December 7, 2020

**Re: Supplemental Data Related to the Request for Correction to NIST's Final Report on the Collapse of World Trade Center Building 7 (Information Quality #20-01)**

Left: The distance between Reade St. and WTC 7. Right: The distance between Leonard St. and WTC 7.

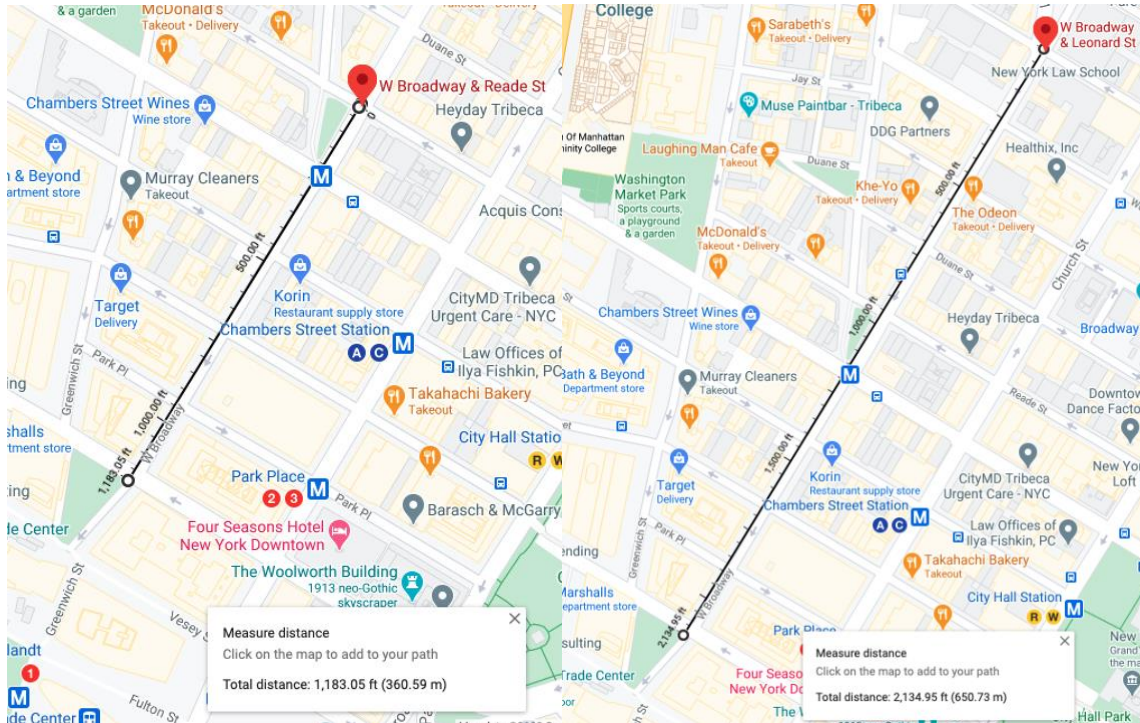
Careful review of the footage played in the 6:30 PM clip reveals that it was shot at the intersection of West Broadway and Reade St., which is roughly 360 meters (~1,180 ft) from WTC 7. This distance is roughly 290 meters closer than the intersection of West Broadway and Leonard St. (which is roughly 650 meters from WTC 7), where MSNBC reporter Ashleigh

Banfield was positioned. (See the Request, p. 57.) It therefore makes sense that the loud sound that caused Banfield to quickly and involuntarily turn toward WTC 7, 650 meters away, would be perceived by **Pergament**, who was almost twice as close to WTC 7, as a “rumble” and **“a loud, incredibly loud explosion.”**

The path from the intersection of Church St. and Reade St. to WTC 7.

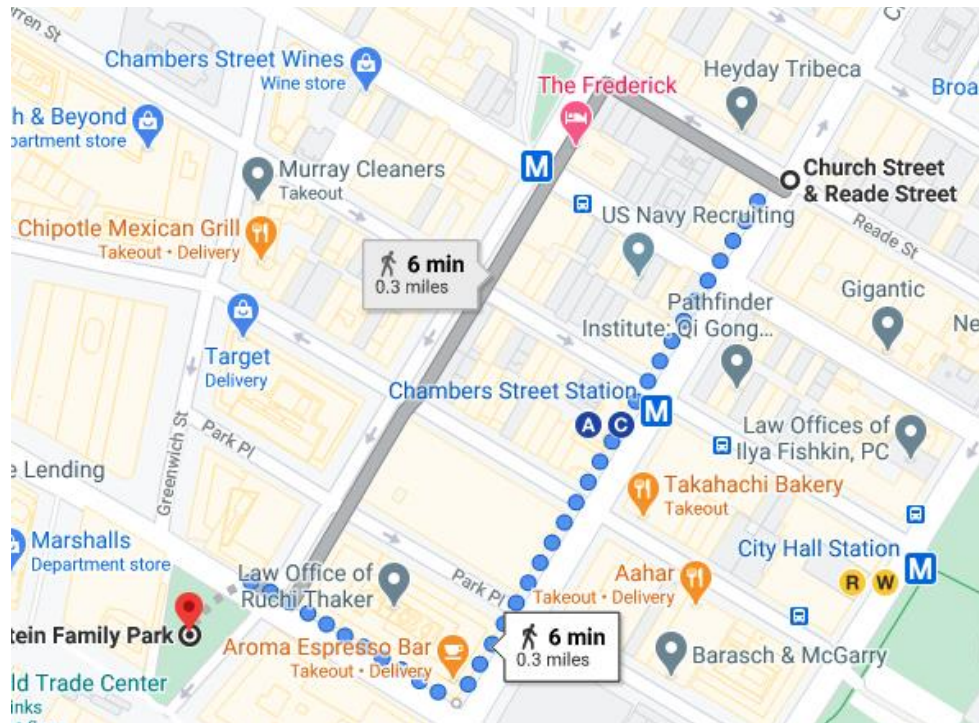
Based on Rossen’s reporting, he was at the intersection of Church St. and Reade St. when WTC 7 collapsed. He was then pushed one block north to Duane St. Church St., which runs north-south, is one block east of West Broadway (where Pergament and Banfield were) and does not lead directly to WTC 7 like West Broadway does, which may have reduced amount of sound that traveled up Church St. compared to West Broadway. Nevertheless, Rossen “heard another tremble” when WTC 7 collapsed.
